BV1 (M-Note) SYSTEM BLOCK DIAGRAM

PROJECT : BV1
Quanta Computer Inc.

Size: Custom Document Number: CLOCK GENERATOR
Date: Thursday, October 06, 2005 Sheet 11 of 73

BV1 / M-Note Schematic EC Tracking Record A (for DV --> SIV) Dec. 28, 2004

Clock Generator

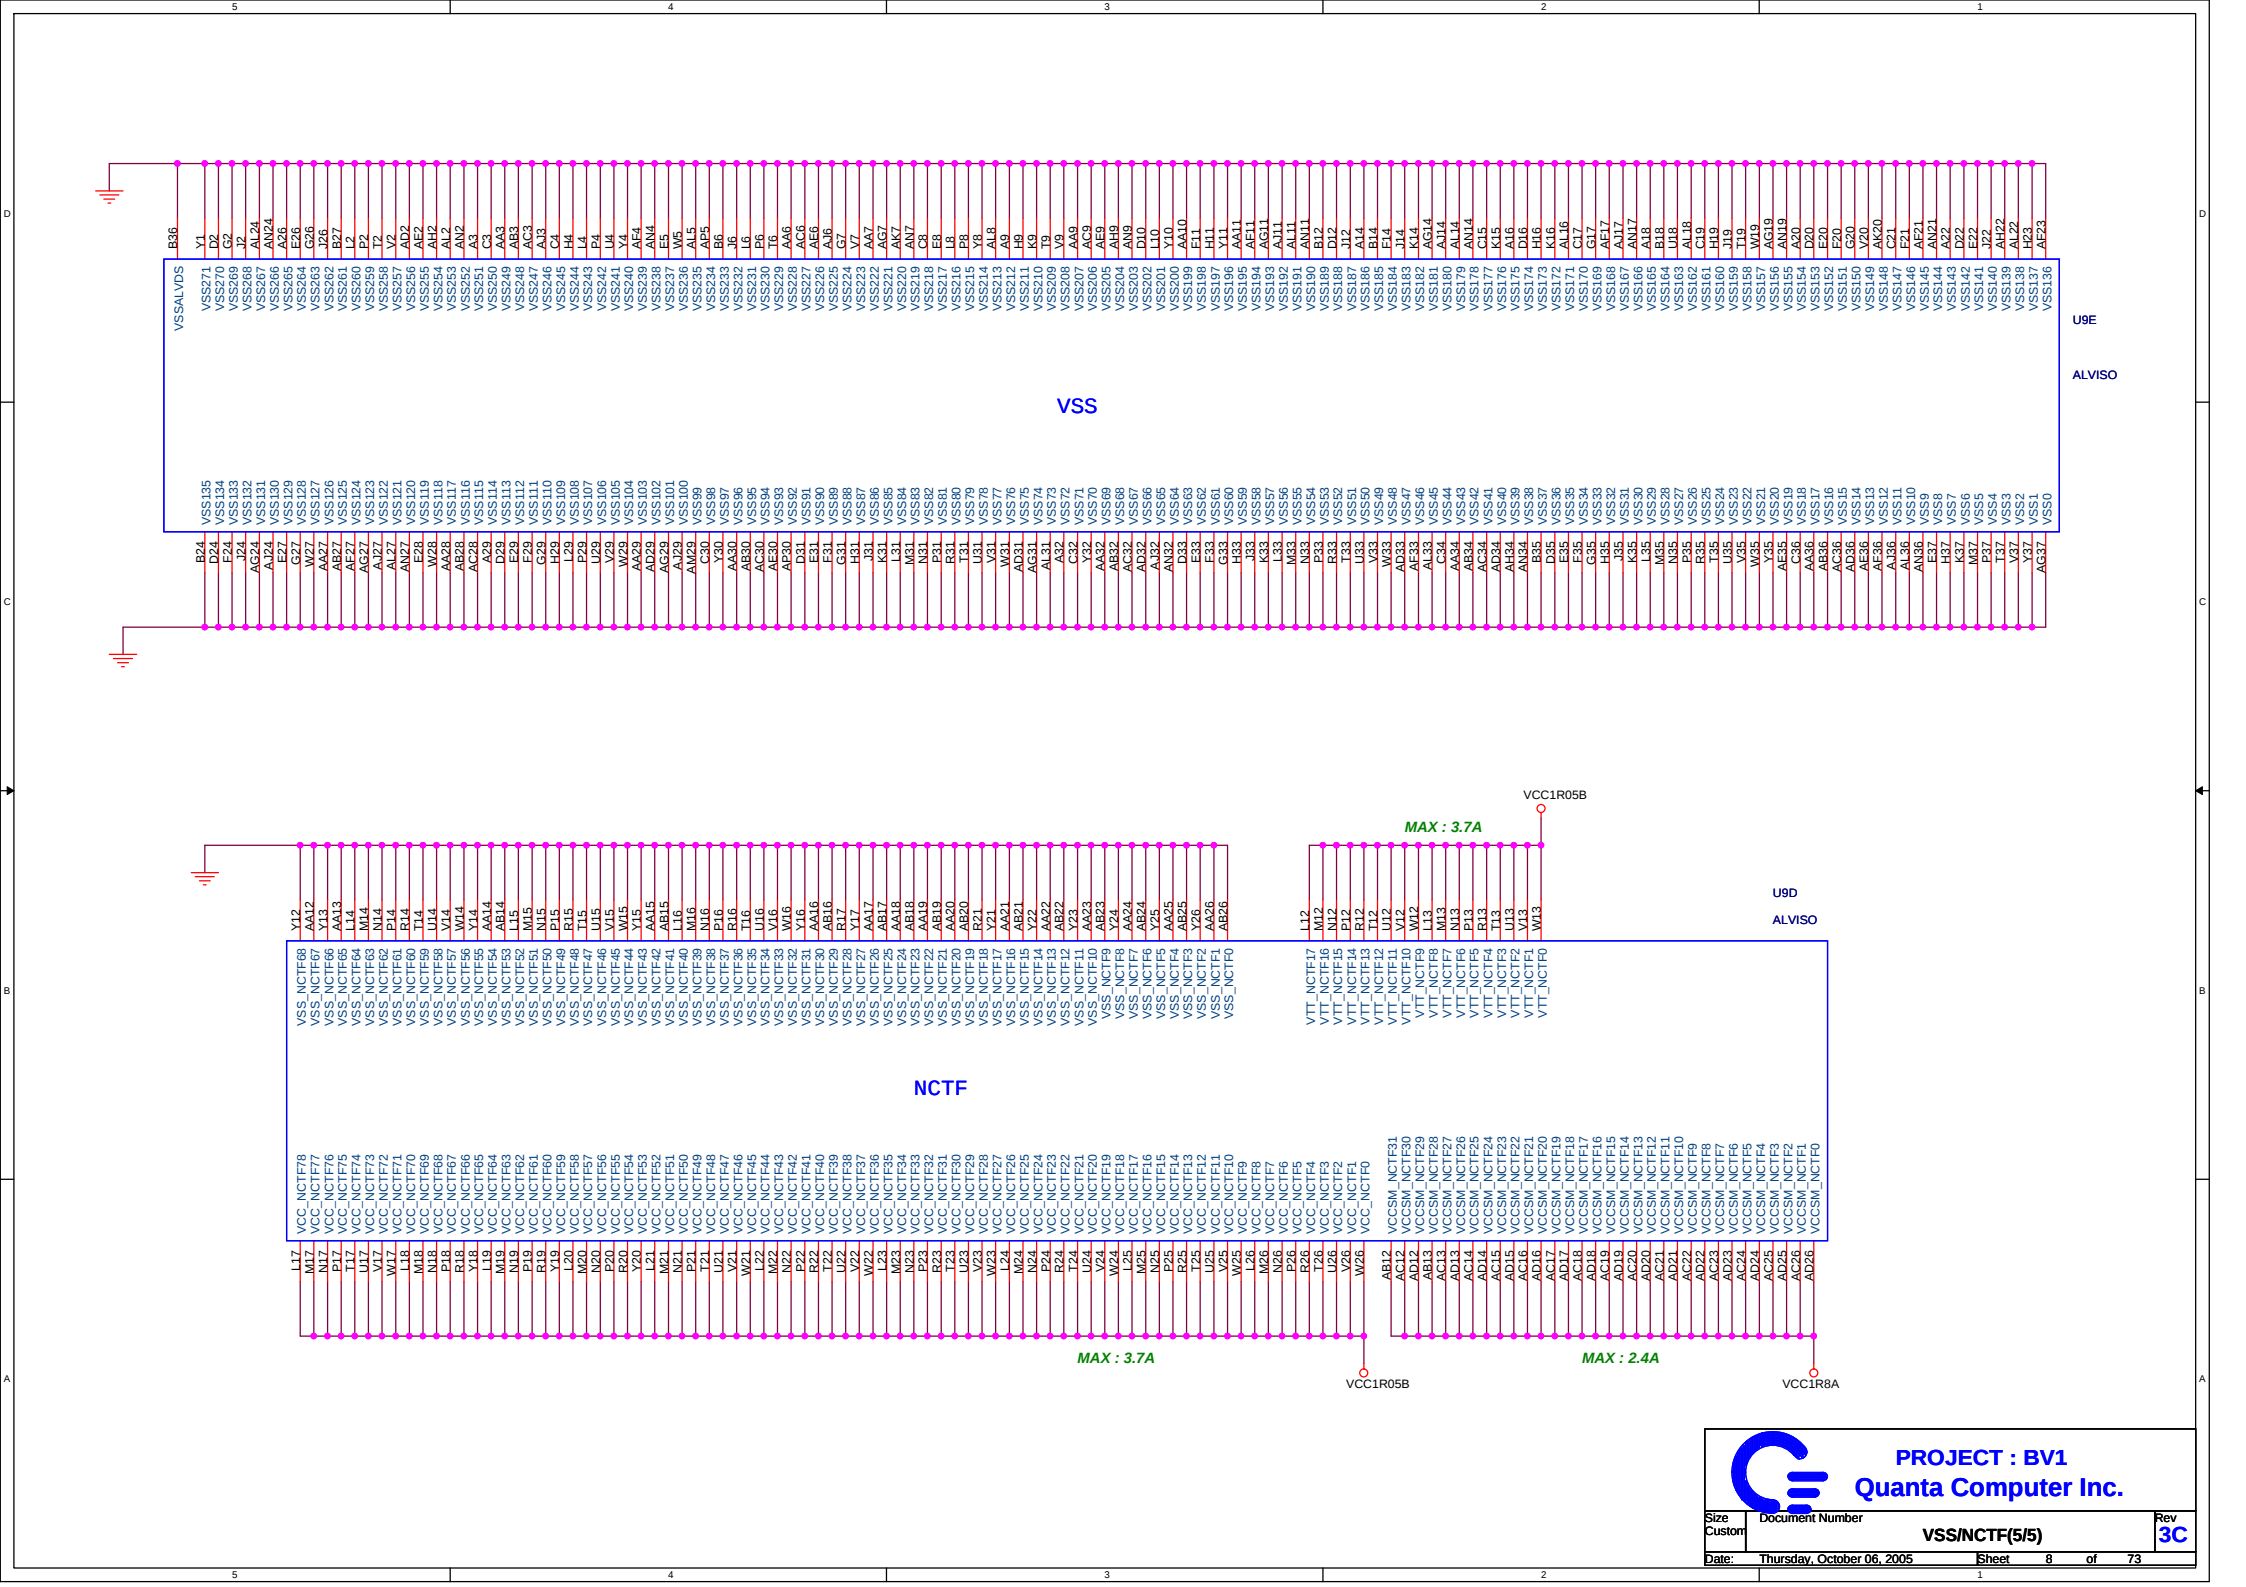
EC B38 EC C23

ODD CONNECTOR

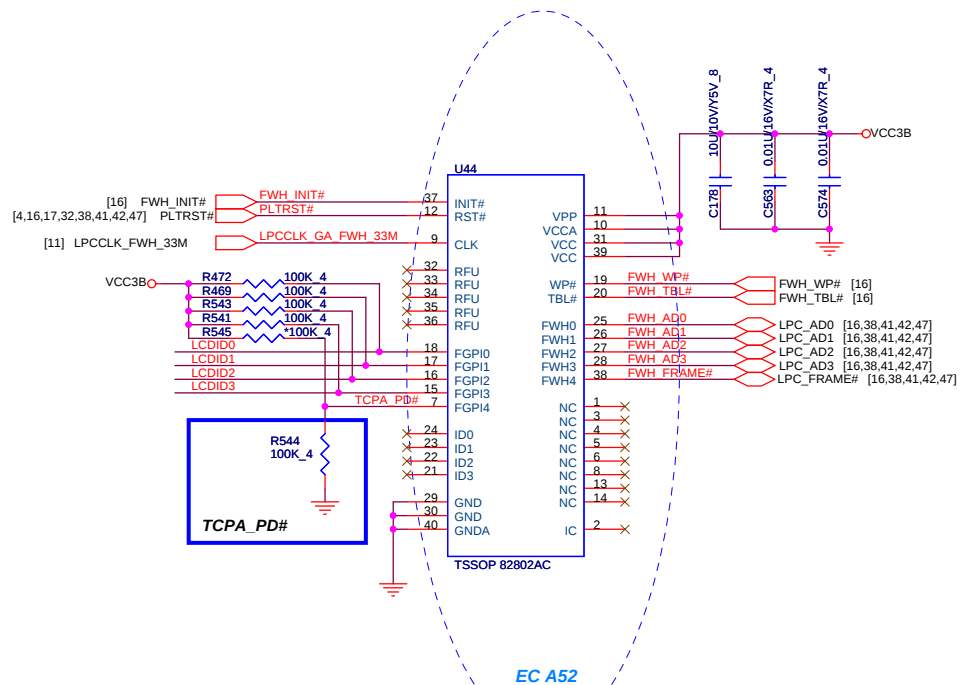
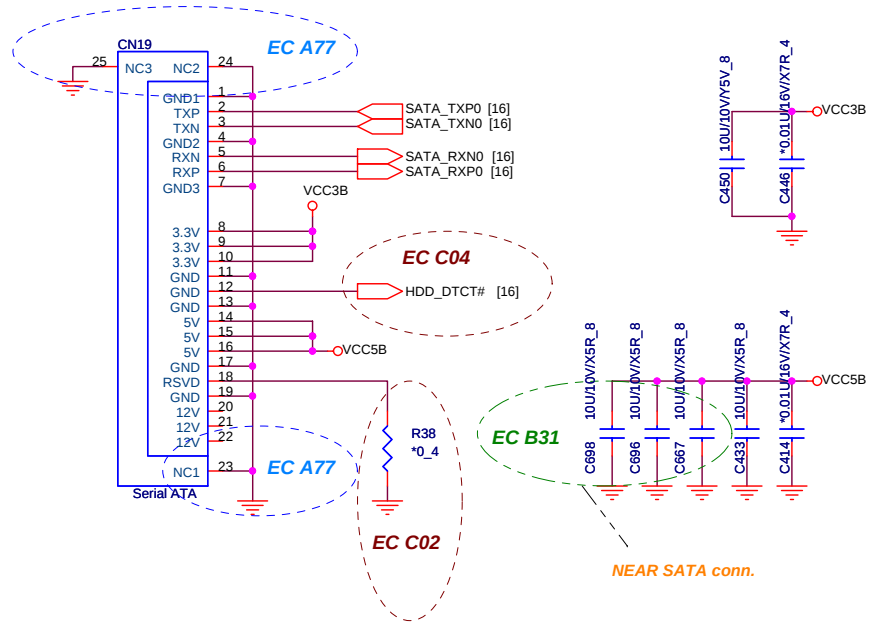
11/24 Change BT1 to be Tyco "1470366-2" and use cable-type coin battery

USB Bracket

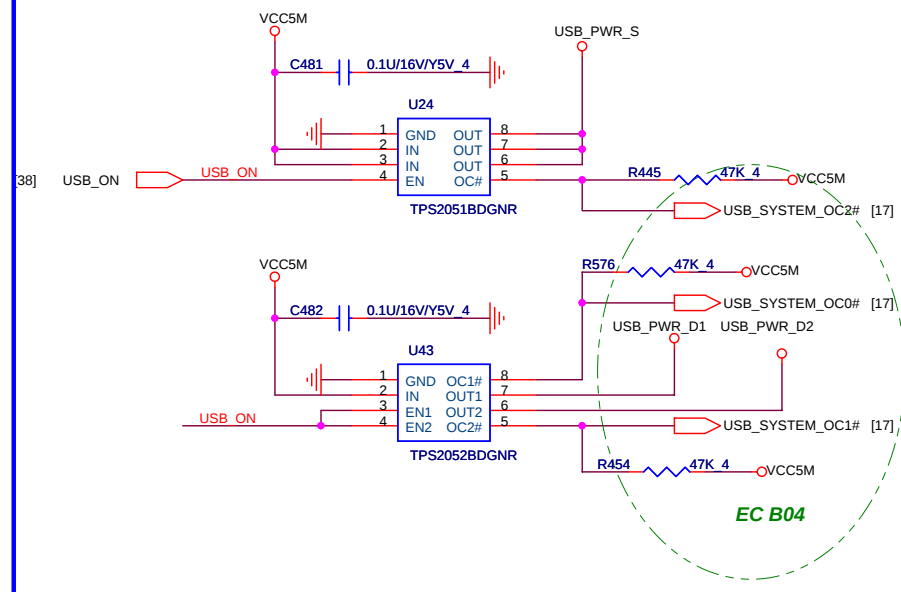
Change to TI solution (TPS2051 + TPS2052 power switch)
2004/12/09 Thunder

MINI PCIE CONN-2 FOR WLAN

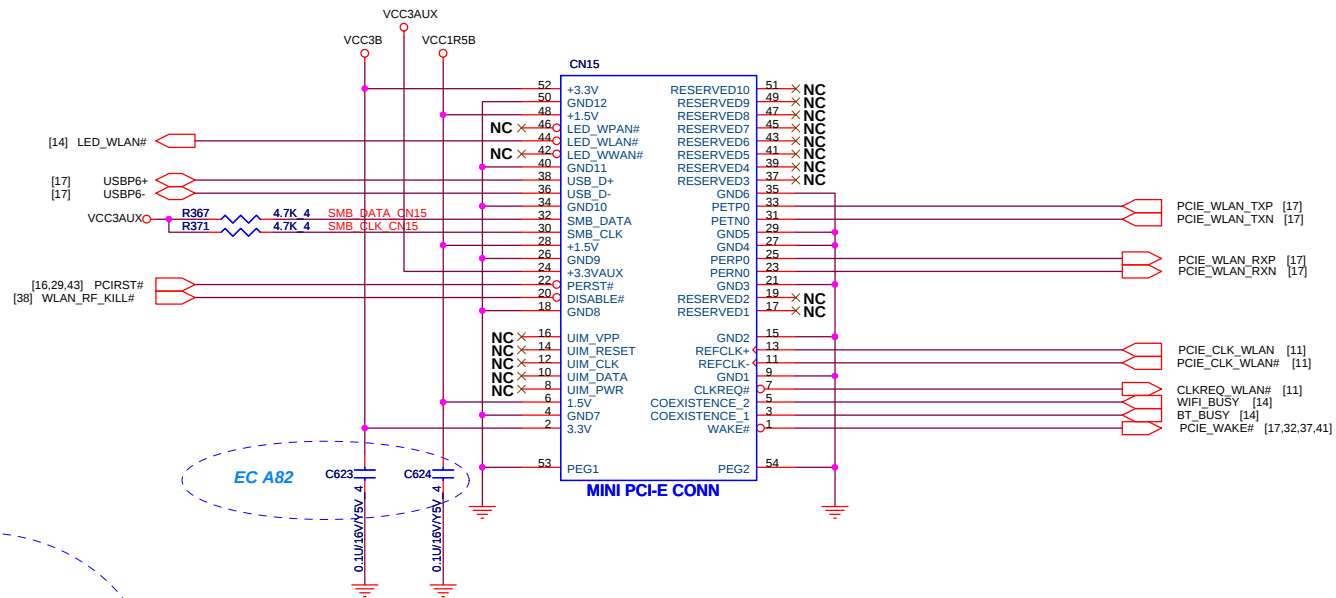
EC A82

EC B05
